U.S. NUCLEAR REGULATORY COMMISSION

Reports No. 50-315/90026(DRS); 50-316/90026(DRS)

Facility Name: D. C. Cook Nuclear Power Station, Units 1 and 2

Type of Meeting: Enforcement Conference

ESSENTIAL SERVICE WATER PUMP CKT. BREAKER CLOSE CIRCUIT
UNIT 1 ESW PUMP CIRCUIT SHOWN (TYPICAL FOR ALL ESW PUMPS)

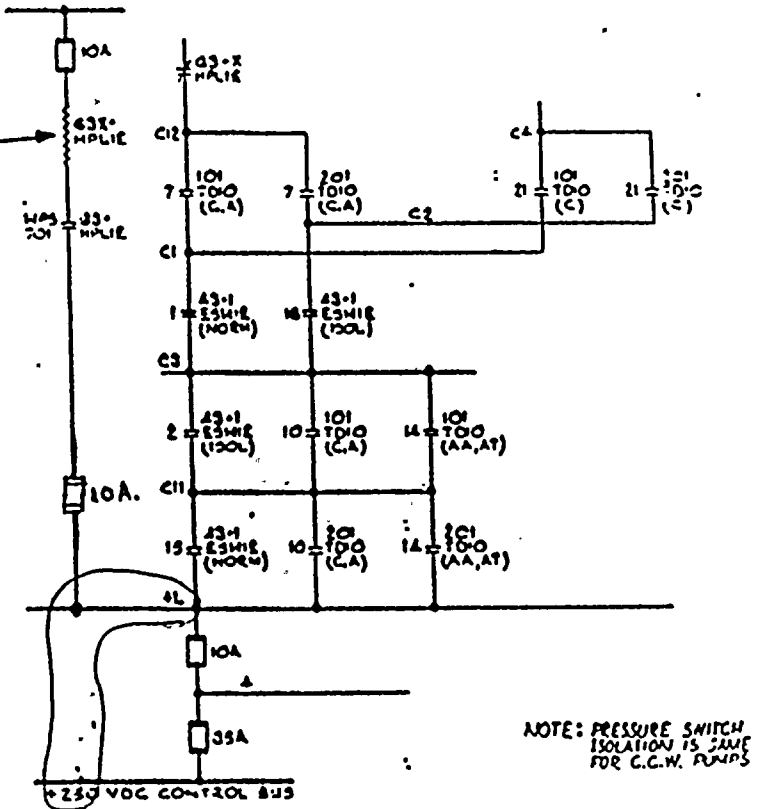
Problem

As Designed

As Translated & Installed

ISOLATION RELAY LOCATED IN SWITCHGEAR

**DESIGN WAS INAPPROPRIATELY
TRANSLATED TO ELEMENTARY DRAWINGS**

**INAPPROPRIATE ENGINEERING & DESIGN
CHECKING OF DRAWINGS IN 1983**

**REPLACE EXISTING 10 AMP. FUSE
WITH 5 AMP.**

**RESTORE CIRCUIT TO
"AS-DESIGNED" CONFIGURATION**

1. CABLE 1-29685G RUNNING BETWEEN LOCAL SHUTDOWN INDICATION (LSI) PANELS 1-LSI-6 AND 1-LSI-6X.

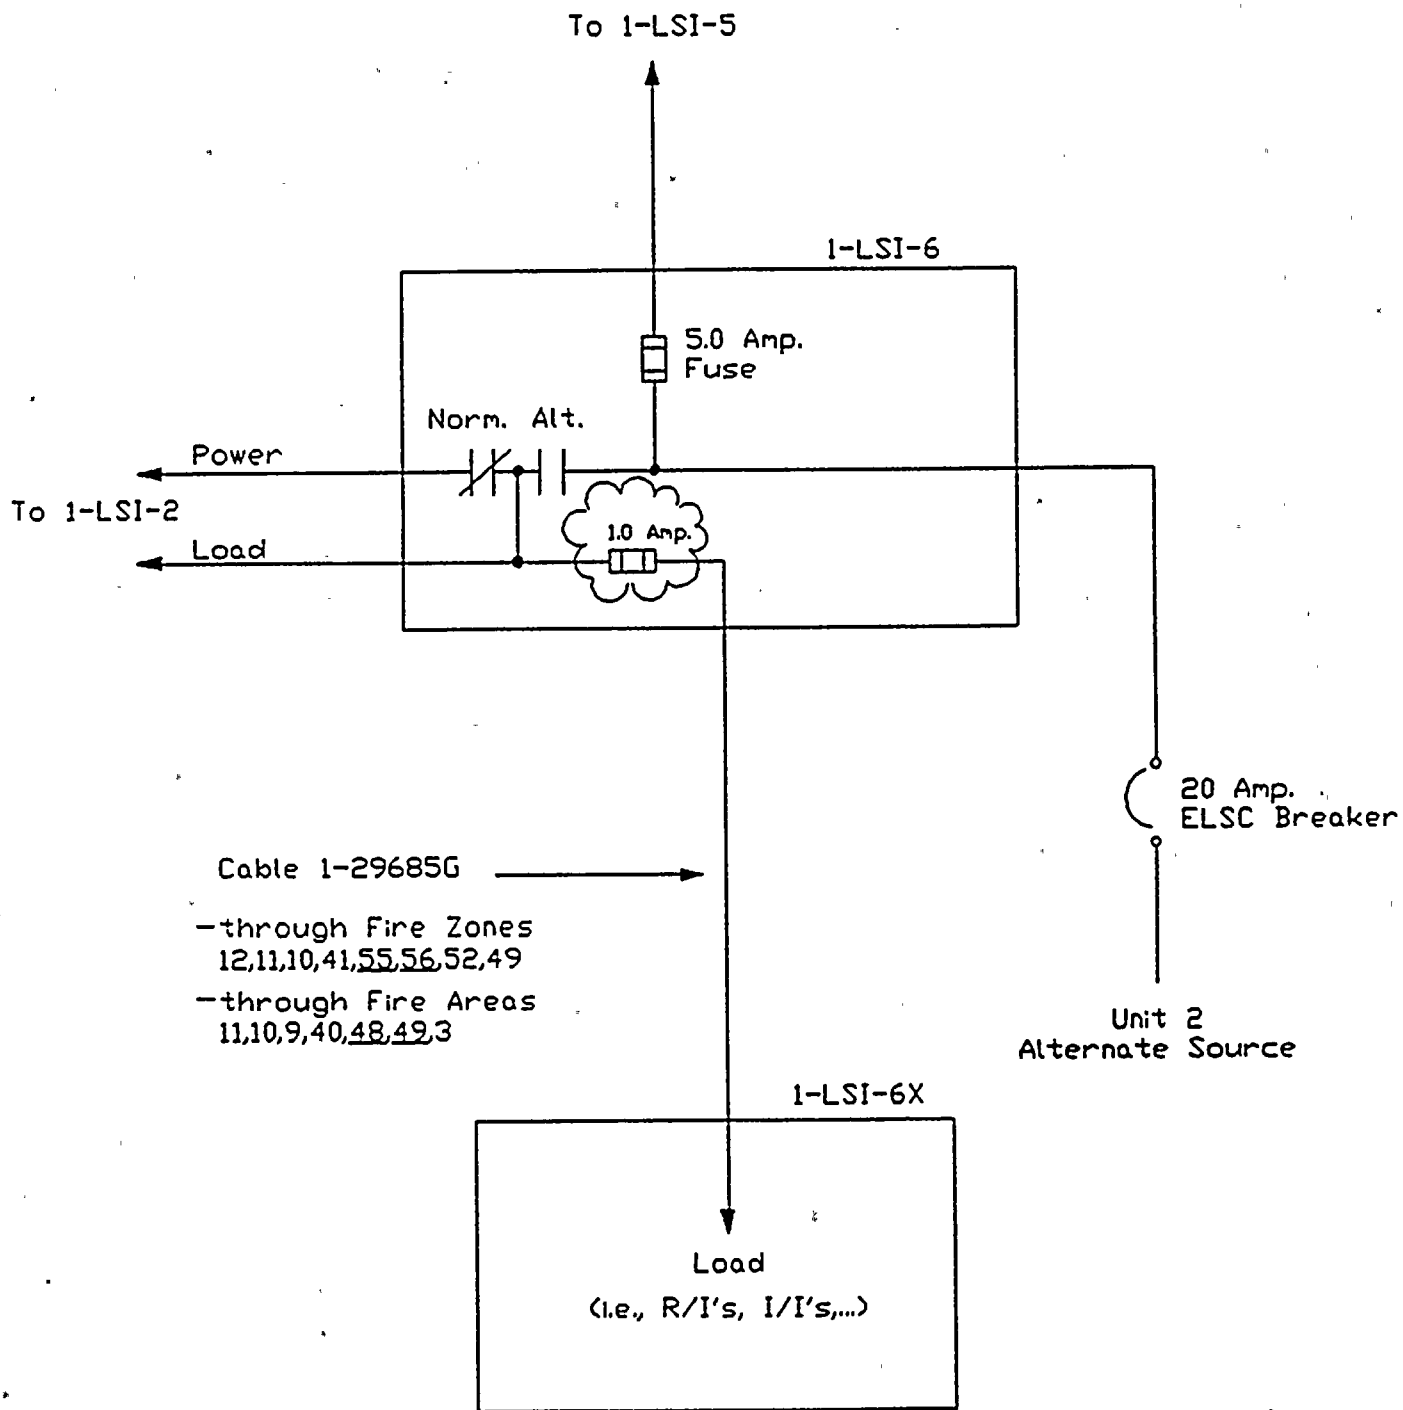
REVIEW OF APPENDIX R SAFE SHUTDOWN CABLE ROUTES BY FIRE ZONE IDENTIFIED A NUMBER OF INSTANCES WHERE THE ACTUAL CABLE ROUTE DIFFERED FROM THE ROUTE DETERMINED IN SUPPORT OF PLANT MODIFICATIONS WITH POTENTIAL APPENDIX R IMPACT. OF THESE INSTANCES, TWO WERE DETERMINED TO VIOLATE APPENDIX R CABLE SEPARATION/ PROTECTION CRITERIA:

BOTH OF THE ABOVE INSTANCES CREATED A POSSIBILITY FOR A FIRE-INDUCED LOSS OF PROCESS MONITORING INSTRUMENTATION REQUIRED BY PROCEDURES. THE LSI CABLE ROUTING DISCREPANCIES WERE REPORTED IN LER NO. 90-010 AND WERE REITERATED BY INSPECTION REPORT NO. 90018 ITEM 4.C. ACTIONS HAVE BEEN TAKEN TO CORRECT BOTH PROBLEMS.

THE UNIT 1 LSI PANEL CABLE ROUTING ERROR CREATED THE POSSIBILITY FOR A FIRE IN FIRE AREAS 48 AND 49 TO DISABLE BOTH THE UNIT 1 CONTROL ROOM AND LSI PANEL PROCESS MONITORING INSTRUMENTATION.

- o ENHANCE PROCEDURES FOR ROUTING SAFE SHUTDOWN CABLES**
- o USE A DATA BASE SOFTWARE PROGRAM AND SAFE SHUTDOWN LOGIC DIAGRAMS TO VERIFY THAT NEW CABLES ARE ROUTED IN ACCORDANCE WITH APPENDIX R REQUIREMENTS**
- o PROVIDE APPENDIX R COMPOSITE DRAWINGS**
- o CONFIRM THE ACCURACY OF SAFE SHUTDOWN CABLE ROUTES**
- o ENHANCE TRAINING FOR NUCLEAR ENGINEERING/DESIGN DEPARTMENTS**

2. CABLES 1-1936R/2-12467

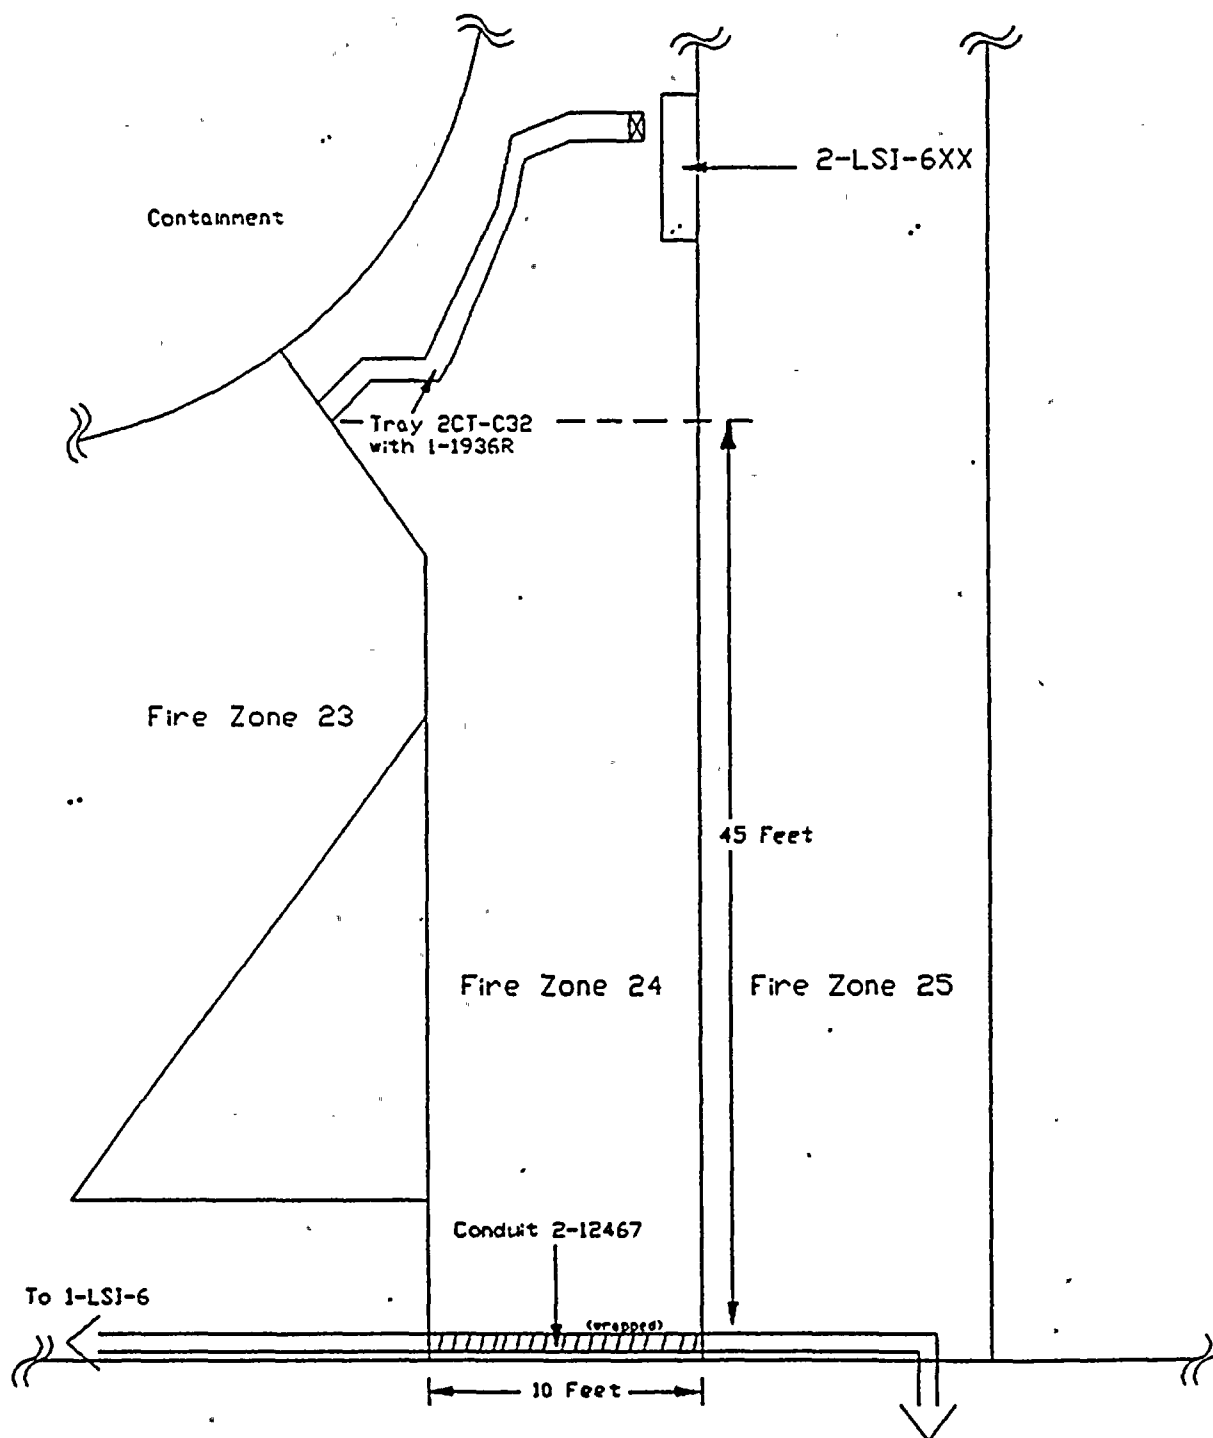
1-1936R = UNIT 1 ALTERNATE POWER SOURCE CABLE
TO THE UNIT 2 LSI PANELS

2-12467 = UNIT 2 NORMAL LSI POWER SOURCE CABLE

THE UNIT 2 LSI PANEL CABLE ROUTING ERROR CREATED THE POSSIBILITY FOR A FIRE IN FIRE ZONE 24 TO DISABLE THE UNIT 2 LSI PANEL PROCESS MONITORING INSTRUMENTATION AND A PORTION OF THE CONTROL ROOM INSTRUMENTATION.
